AGENDA

Village of Chenequa Plan Commission Monday, May 13, 2024 at 6:00 p.m. 31275 W. County Road K, Chenequa, WI 53029

STAFF REVIEW

STAFF REVIEW

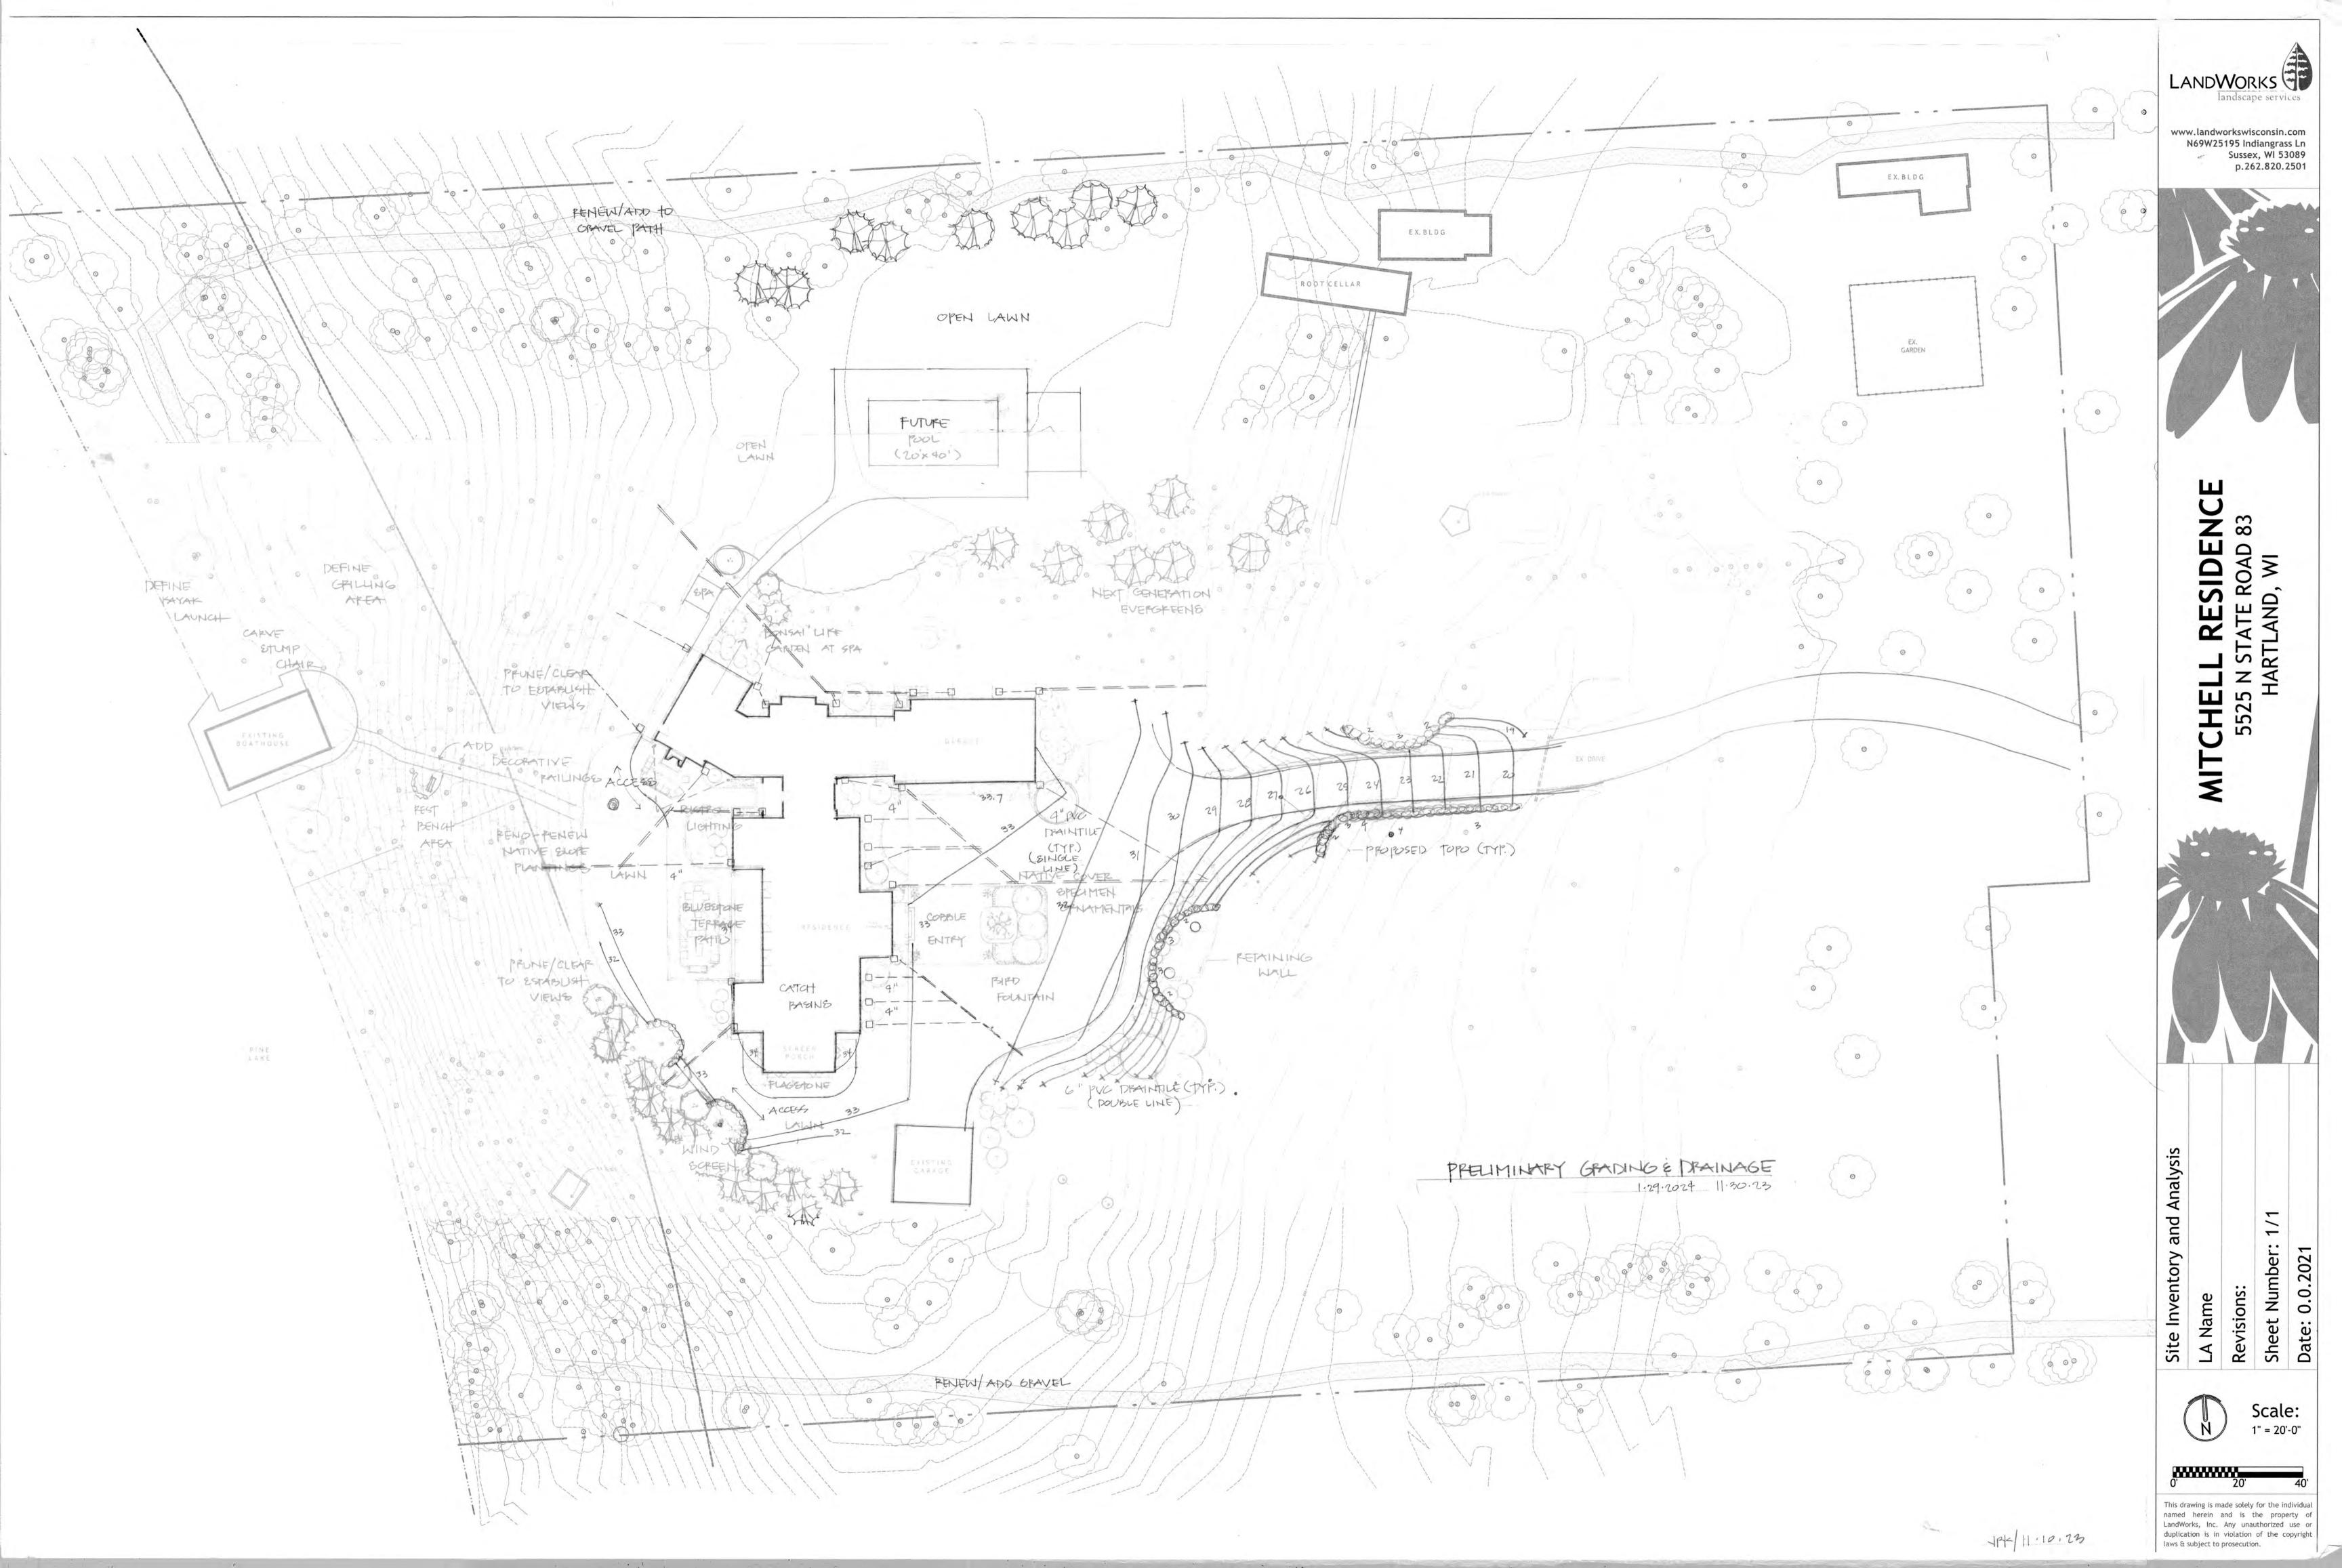
- 1. Landworks has recently submitted a landscape and lighting plan on behalf of the Mitchell family.
- 2. A complete landscape and grading plan with a photo book of sample materials and proposed plantings is provided in the Plan Commission and Village Board packet.
- 3. All proposed landscaping and landscape lighting is currently beyond the 75' setback from the OHWM of Pine Lake.
- 4. Landscaping includes;
 - One at grade patio on the lakeside of dwelling
 - This patio is entirely outside the 75' shoreland buffer setback.
 - The patio is proposed to be constructed from "pattern bluestone"
 - Various pathways
 - Around the perimeter of the home there are various proposed paths and stepping stones.
 - These paths are proposed to be constructed of irregular bluestone with a granite cobble border
 - The stepping stones will be constructed of irregular bluestone.

- Tree Wells
 - There are three retaining wall/tree wells proposed around the house.
 - These tree wells are proposed to be constructed of blue granite boulders

- All walls are outside of the 75' setback on plan
 - Location can be found on the provided landscape plan
- Spa feature
 - On the north side of the residence the applicant is proposing a spa feature as shown on plans.

- o The spa feature is proposed to be constructed of stainless steel
 - The spa feature is proposed to be 7.5'X7.5'
 - This spa feature is not within the 75' setback of Pine Lake and is greater than 100' from the nearest property boundary.

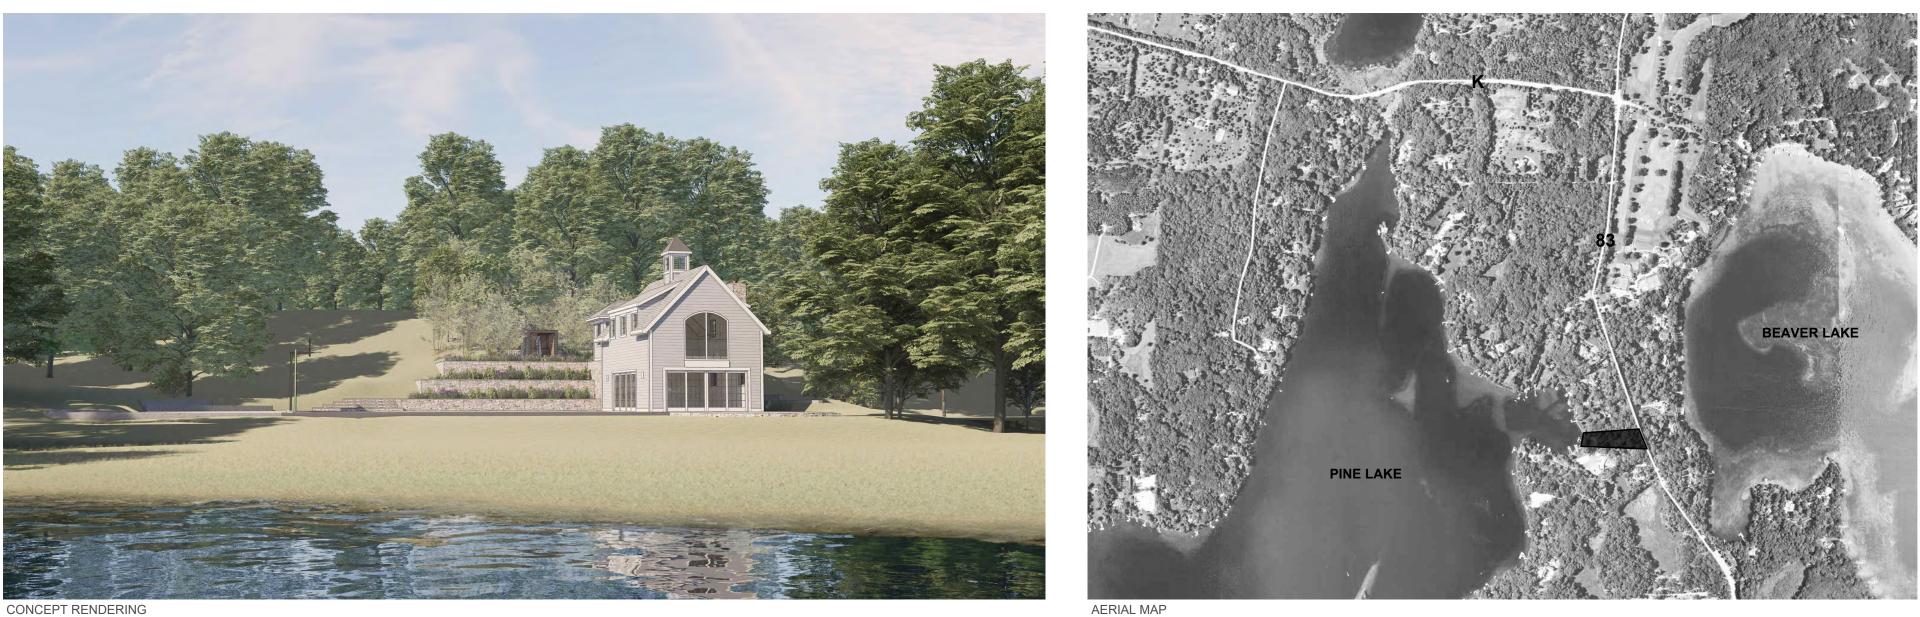
COMMENTS:

- 1. The applicant proposes to place a 6-person modular sauna structure on the lakeside of the primary dwelling.
- 2. The footprint of the sauna structure is approximately 45 square feet
- 3. The structure's exterior sheathing is constructed of wood-tone materials. The lakeside elevation is mostly glass.
- 4. "As seen from the lake" color renderings are provided in your packets
- 5. Proposed location has been shown on the site plan in the packets.
- 6. This structure meets the requirements of 6.5(4)(a)(i) because it is greater than 75' from the OHWM.
- The proposed detached accessory structure is over one hundred (100) feet to any existing single-family structure on an adjoining lot which complies with section Sec. 6.5(c)(i).

- 8. A building permit is required from the Building Inspector prior to start of construction.
- c: Dan Neumer, Administrator Deanna Braunschweig, Clerk Paul Launer, Lake Country Inspections Katherine Quadracci-Flores, Owner

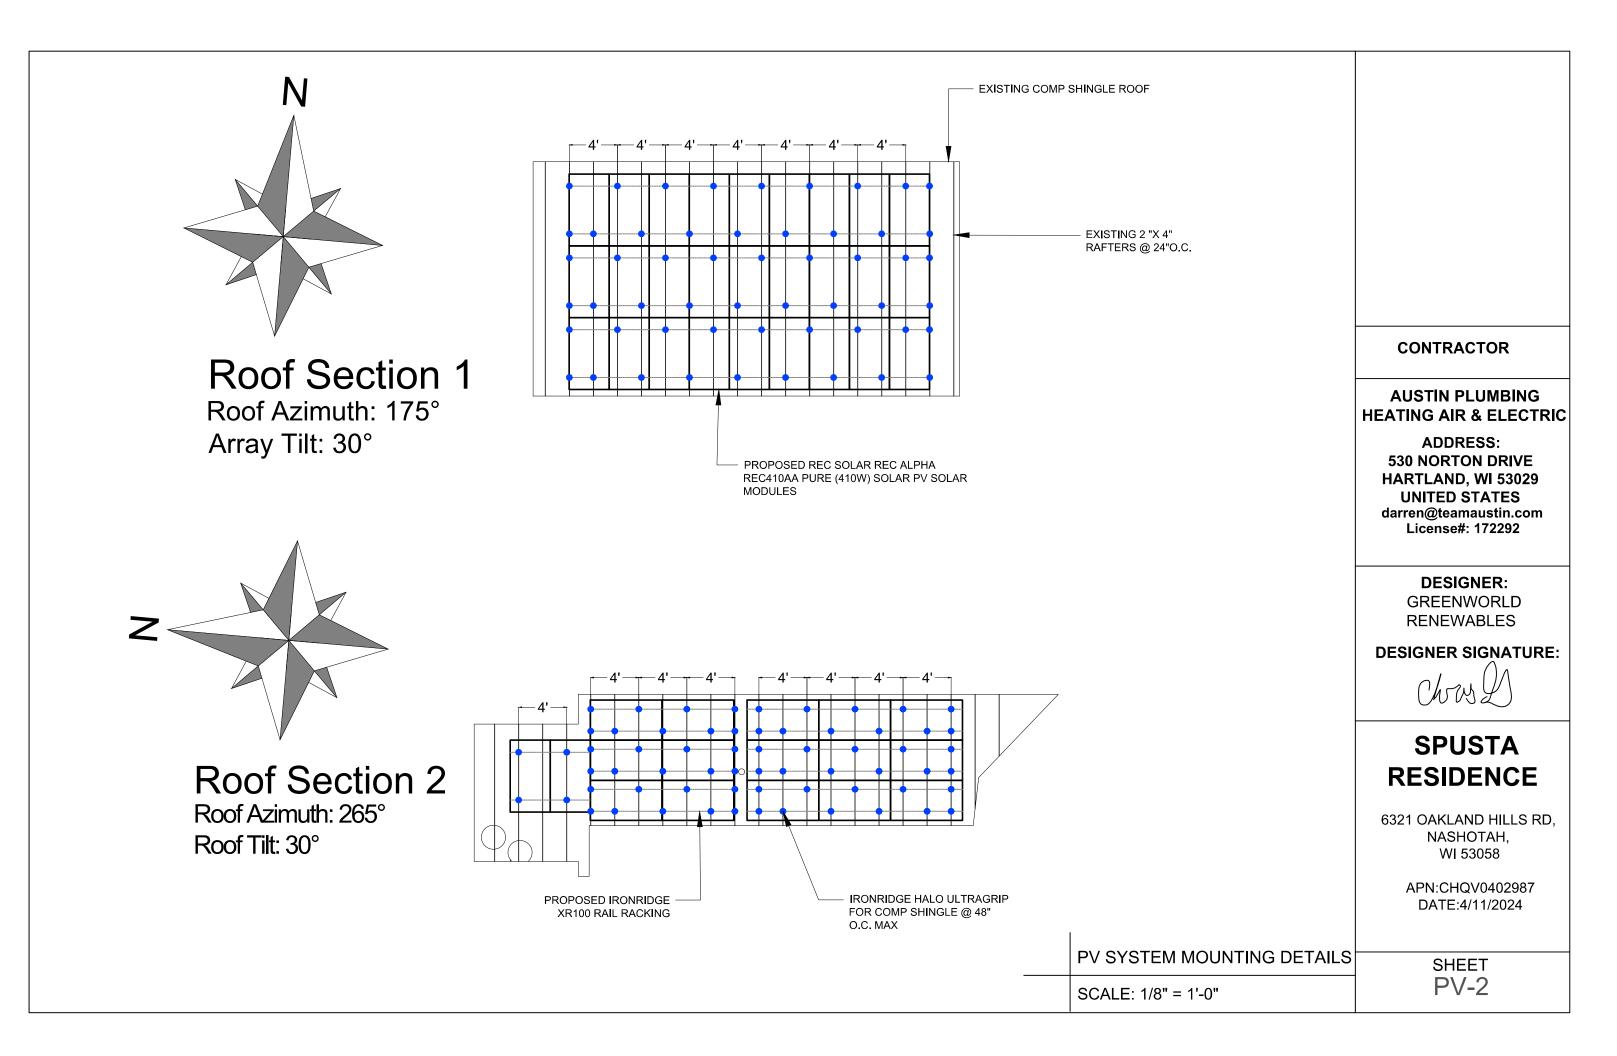
- 1. The applicant proposes to install two roof mounted solar arrays on the existing dwelling
 - a. Page three of the packet shows proposed panel locations
 - i. A 27-panel array is proposed to be mounted over the garage and facing southward
 - ii. A 17-panel array is proposed to be mounted on the house facing westward.
- 2. The proposed panels will not result in an increase in structure height
- 3. The proposed panels are pure black as shown on page 9 of the included packet.
- 4. This is a legal conforming lot
- c: Dan Neumer, Administrator Deanna Braunschweig, Clerk Paul Launer, Lake Country Inspections Denise Spusta, Owner Cody Lincoln, Zoning Administrator
